**Pwyllgor** PWYLLGOR CYNLLUNIO

**Dyddiad ac amser  
y cyfarfod** DYDD MERCHER, 13 CHWEFROR 2019, 10.30 AM

**LATE REPRESENTATIONS SCHEDULE**  
**PLANNING COMMITTEE –13<sup>TH</sup> FEBRUARY 2019**

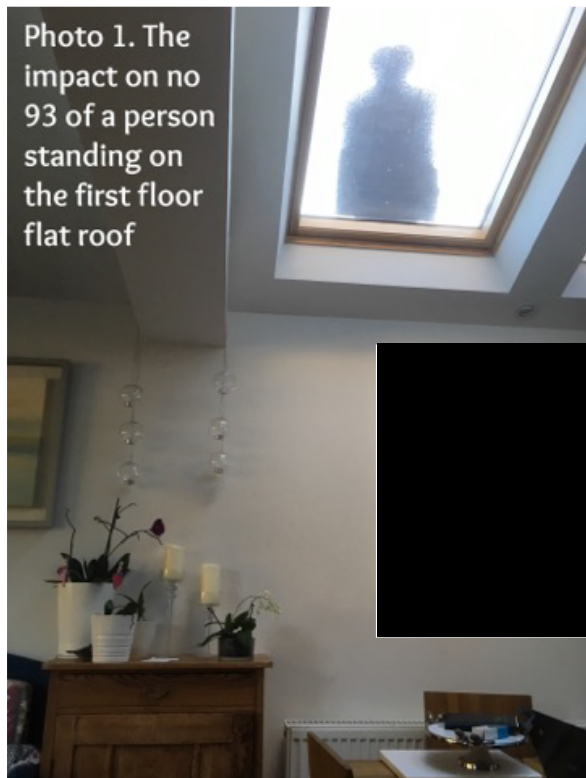
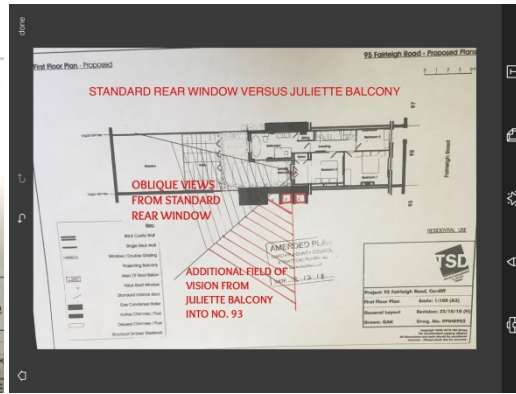
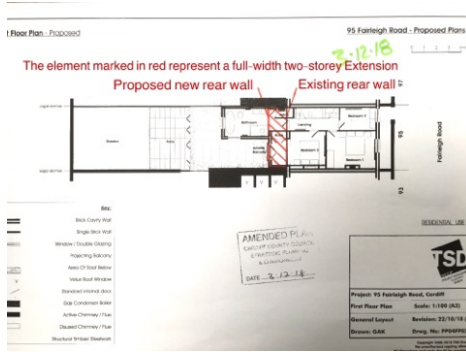
6. Point 8.5 "It is considered that the rear facing window of the dormer extension ....."

This is incorrect and misleading.

The dormer extension comprises 2 single Juliet balconies and a further two windows. (see elevation)
